Abir Fashions (9799)

House # 44, Road # 2, Kutubail (Post Office Road), Fatullah, Narayangonj

23.AUGUST.2014

Identified Priority 1 Concerns

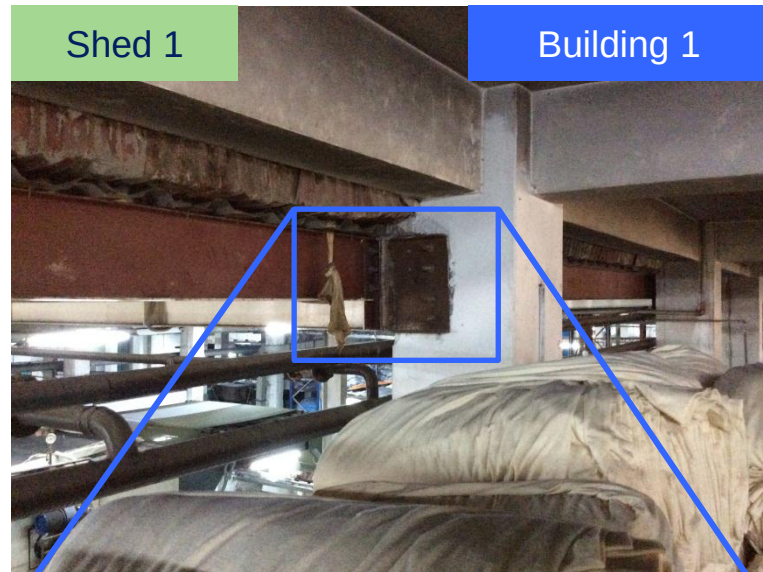
Uncontrolled heavy storage loading was found on the mezzanine, 1st floor, 3rd floor and 5th floor of Building 1 and 1st floor and 2nd floor of Building 2, Building 3 and Building 4. Loading in these area should be reduced to 2.0 kPa and we require that this concern be investigated in a Detailed Engineering Assessment. Loading plans should be clearly displayed in these areas.

Item No.	Observation	Recommended Action Plan	Recommended Timeline
1	Priority 1 - Uncontrolled heavy storage loading in Building 1, Building 2, Building 3 and Building 4.	Reduce stacking height to ensure total load does not exceed 2.0 kPa. A Detailed Engineering Assessment is required to review the design and loads. Factory Engineer to state the maximum weight that is allowed per square meter. Suggest that state the value on notice boards in these areas. (Loading Plans).	Immediate – Now
2	Priority 1 - Uncontrolled heavy storage loading in Building 1, Building 2, Building 3 and Building 4.	Adopt some sort of signage/staff guidance to ensure that the maximum weight of storage is not exceeded. (Loading Plans).	6-weeks
3	Priority 1 - Uncontrolled heavy storage loading in Building 1, Building 2, Building 3 and Building 4.	Maintain standards of quality control to ensure that storage procedures are correctly followed so that overloading problems do not arise in the future. Maintain and implement Loading Plans.	6-months

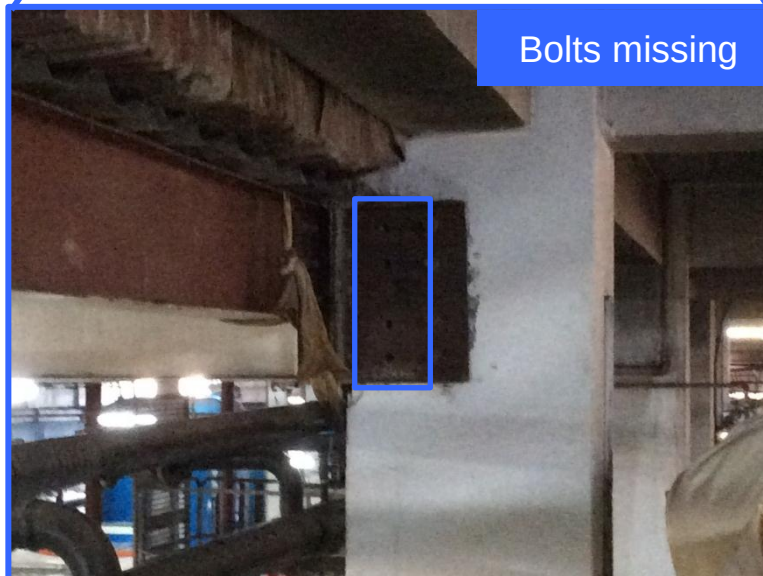
Uncontrolled heavy storage loading was found on the 3rd floor and 4th floor cantilevered slabs in Building 1 and 1st floor and 2nd floor of Building 2, Building 3 and Building 4. The loading was also leaning on the brick walls. These lack lateral load resistance. The loading in these areas should be removed and we require that this is investigated in the Detailed Engineering Assessment.

4	Priority 1 - Uncontrolled heavy storage loading on cantilevered slabs in Building 1, Building 2, Building 3 and Building 4.	Remove heavy storage loading in the area identified above. A Detailed Engineering Assessment is required to review the design and loads. Factory Engineer to state the maximum weight that is allowed per square meter. Suggest that state the value on notice boards in these areas. (Loading Plans).	Immediate – Now
5	Priority 1 - Uncontrolled heavy storage loading on cantilevered slabs in Building 1, Building 2, Building 3 and Building 4.	Adopt some sort of signage/staff guidance to ensure that the maximum weight of storage is not exceeded. (Loading Plans).	6-weeks
6	Priority 1 - Uncontrolled heavy storage loading on cantilevered slabs in Building 1, Building 2, Building 3 and Building 4.	Maintain standards of quality control to ensure that storage procedures are correctly followed so that overloading problems do not arise in the future. Maintain and implement Loading Plans.	6-months

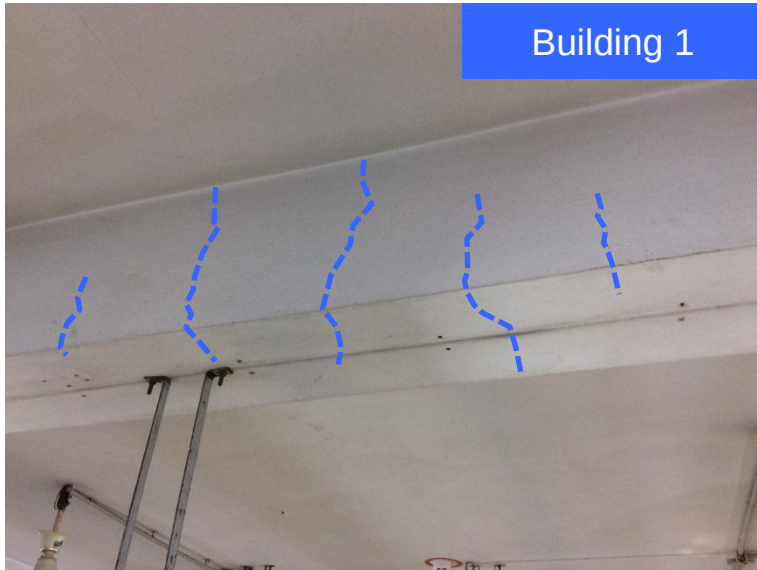
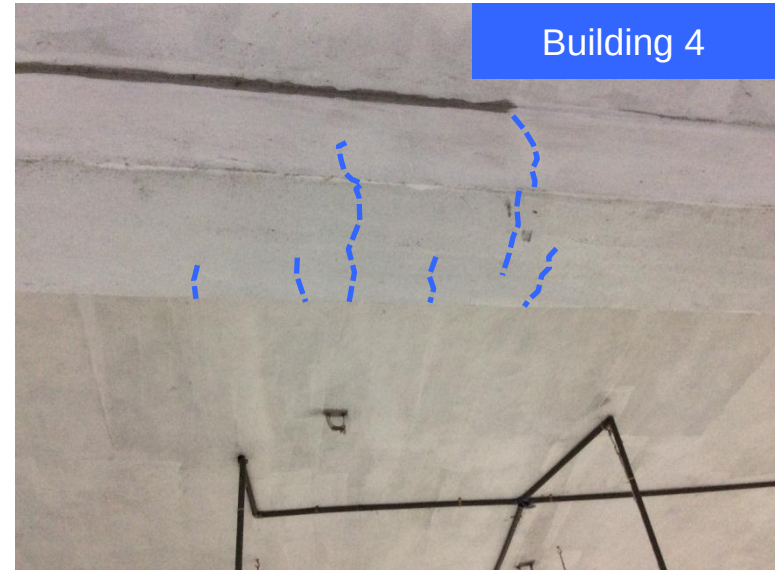
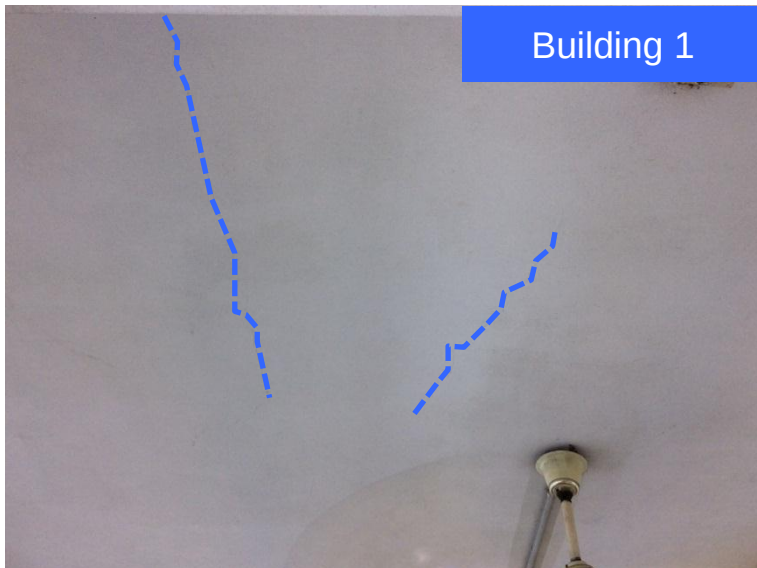
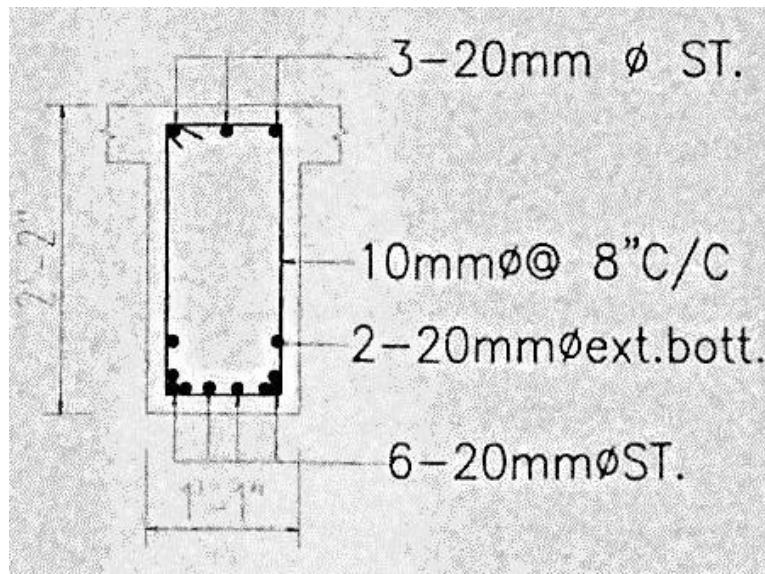
Cracks on 2nd floor, 3rd floor, 4th floor and 5th floor beams of Building 1. Cracks on 1st floor and 2nd floor beams of Building 2, Building 3 and Building 4. And cracks on 3rd floor and 4th floor slab soffits of Building 1.

The cause of cracks should be investigated by appropriate methods, rectified and then the beams repaired.

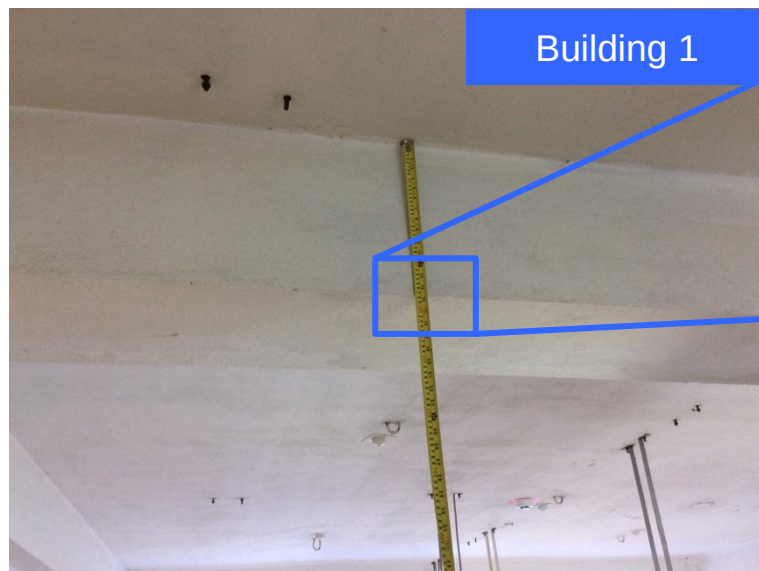
The depth of beam FB-2 measured in situ is 14" excluding slab thickness. This is smaller than those specified on the structural drawings (19" excluded slab thickness).

The structural drawings of Building 1 need to be revised.

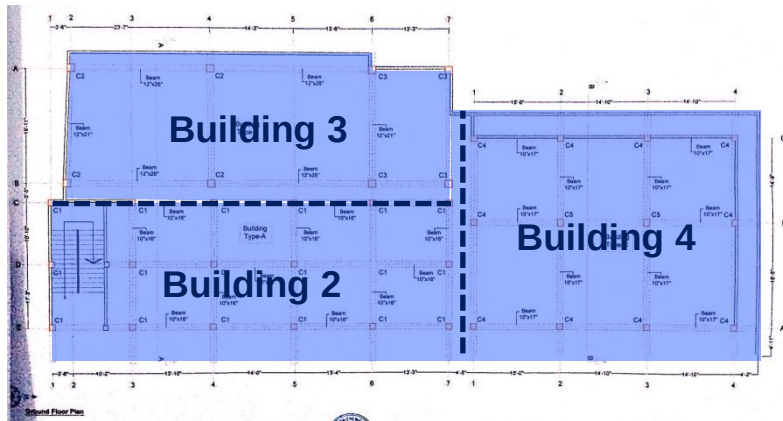
There are inclined columns on the 6th floor of Building 1.

There are inclined roof trusses noted in Shed 1.

Stability for these items and related elements need to be checked.

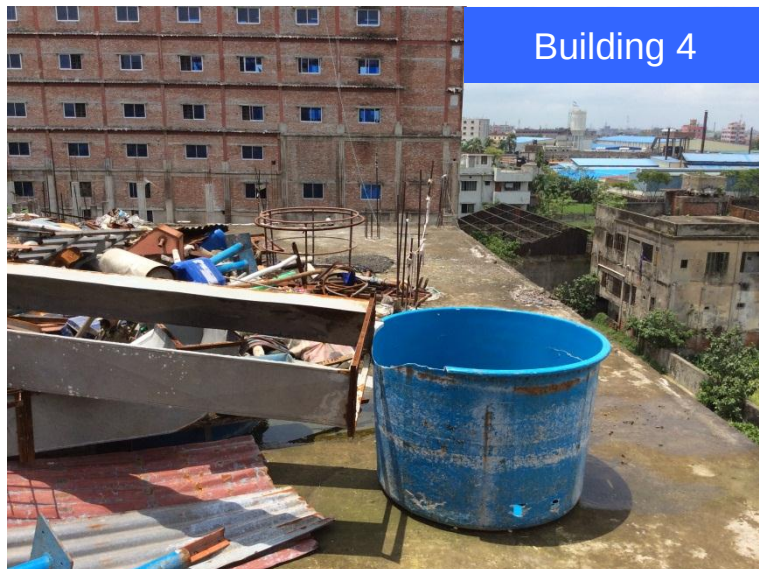
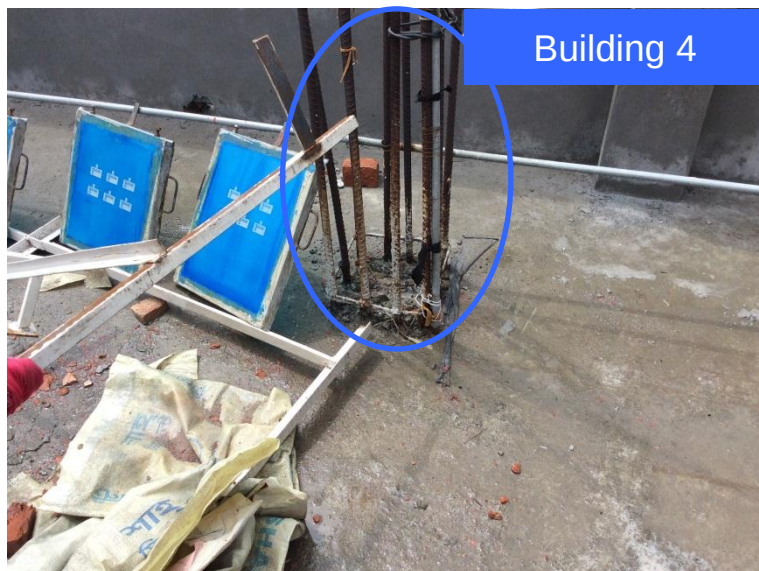
There is no parapet wall around the perimeter of top level of Building 2 and Building 4.

Whilst not a structural issue, this is a significant health and safety risk and should be rectified.

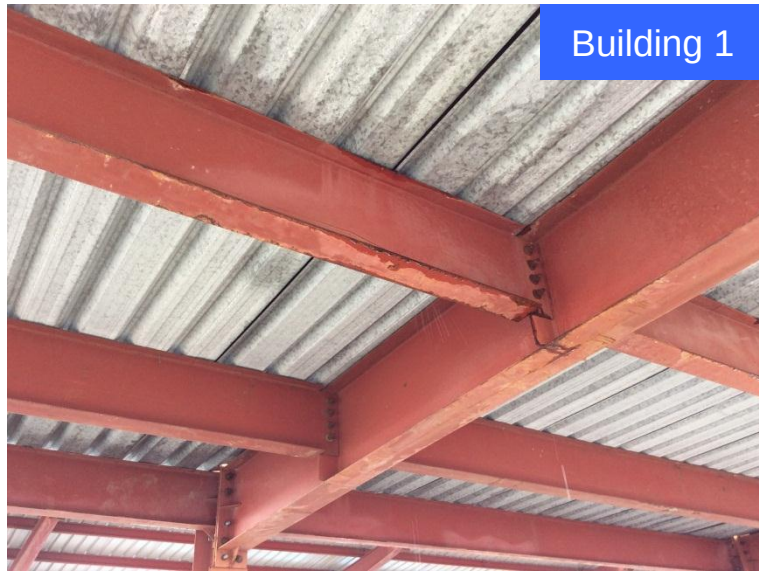
Reinforcement is left exposed on Building 1, Building 2, Building 3 and Building 4. And structural steel elements are also left exposed on Building 1.

No fireproofing material was noted on any structural steel elements (if required).
